ISO/IEC/IEEE 8802-3

AMENDMENT 8
2021-10

AMENDMENT 8: Physical layer specifications and management parameters for 2.5 Gb/s, 5 Gb/s, and 10 Gb/s automotive electrical ethernet

Reference number
ISO/IEC/IEEE 8802-3:2021/Amd.8:2021(E)

Figure 44–1—Architectural positioning of 10 Gigabit Ethernet

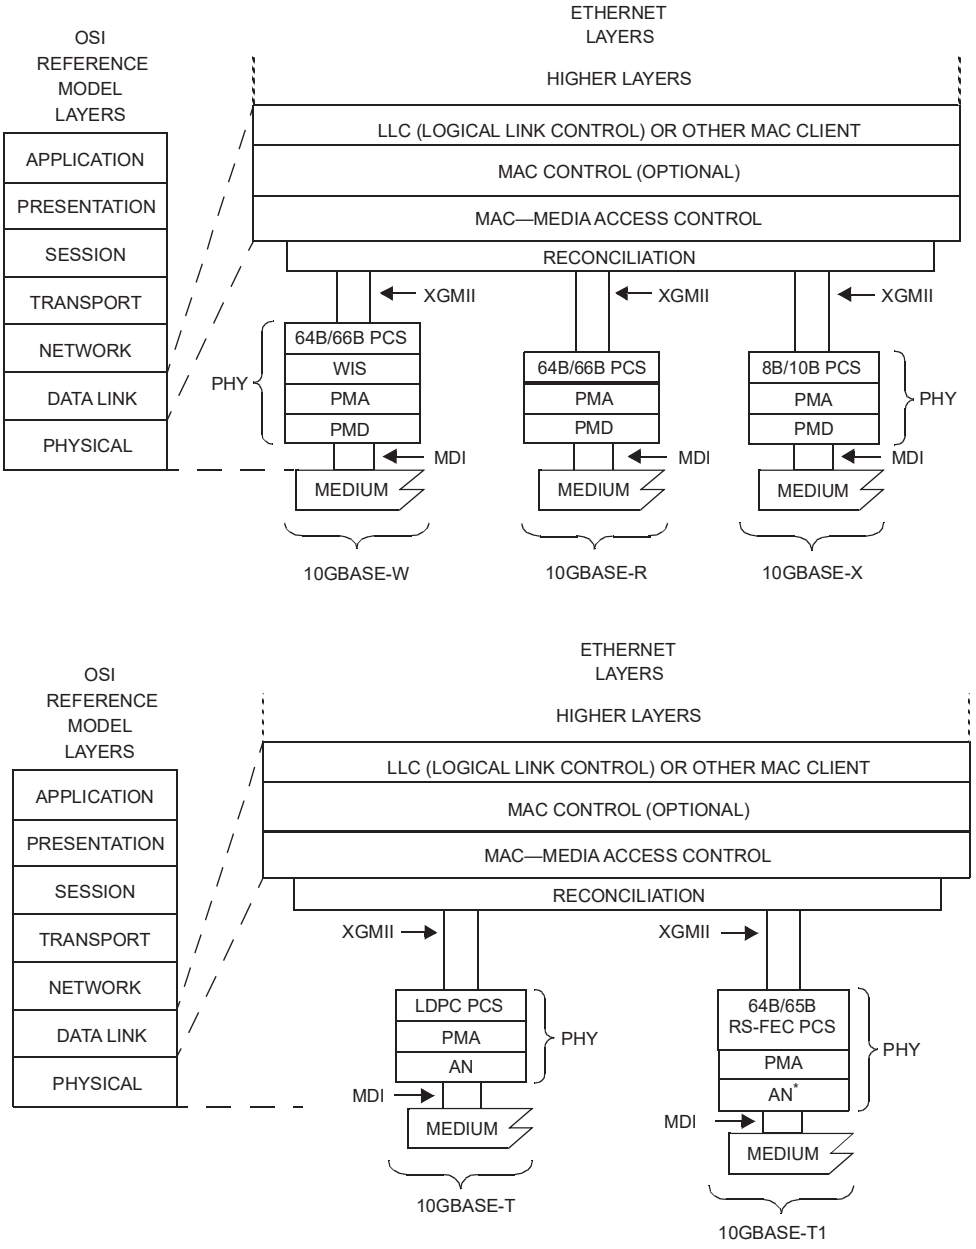
Replace Figure 44-1 with the following figure, which adds 10GBASE-T1:
